**AGENDA**  
**TOWN OF LISBON & VILLAGE OF MERTON**  
**JOINT PLANNING COMMITTEE MEETING**  
**LISBON TOWN HALL**  
**TUESDAY, OCTOBER 10, 2019**  
**6:00 P.M.**

**Minutes of the Town of Lisbon & Village of Merton  
Joint Planning Committee Meeting  
Village of Merton Community Center  
Tuesday, August 20, 2019  
6:30 P.M.**

This letter is intended to accompany our submittal for our application to the Town of Lisbon for the requested CUP Application, Site Plan Review Application, and CSM Application for our proposed project located at N67W27619 Silver Spring Drive. We are proposing rebuilding our Retail Convenience Store with Fueling Canopy at this current site.

# CERTIFIED SURVEY MAP NO. \_\_\_\_\_

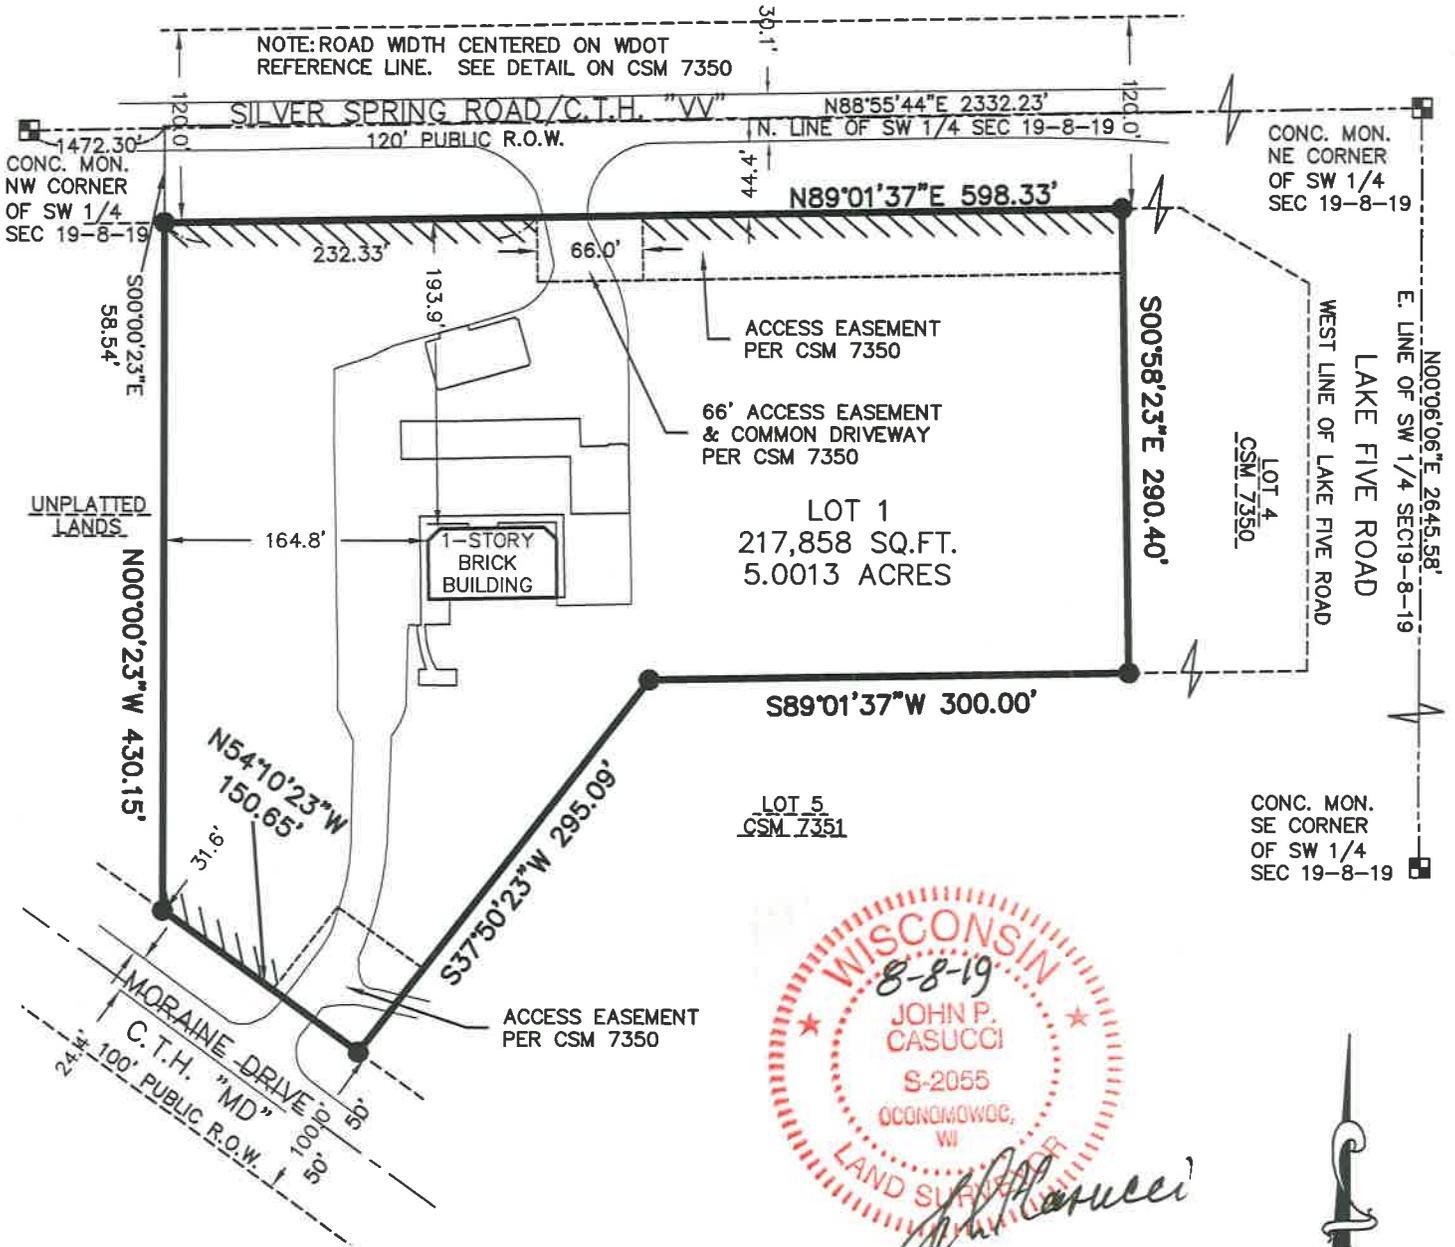
2. Sec. 4.02(g) states that a CSM must identify the owners of record of adjacent unplatted lands. There are lands to the west of the site that are unplatted, but the Applicant did not show the name of the owner of these lands on sheets 1 or 2 in the CSM.

7. Sec. 4.02(m) states that a CSM must list existing zoning adjacent to the proposed CSM. The CSM does not show the existing zoning for Lot 4 of CSM 7350 on sheet 2, located immediately east of the proposed CSM.

9. Sec. 4.02(r) requires a CSM to show the location of soil percolation tests on the site. This information is not shown on the CSM.
10. The existing freestanding sign locations shall also be shown on sheets 1 and 2 of the CSM.
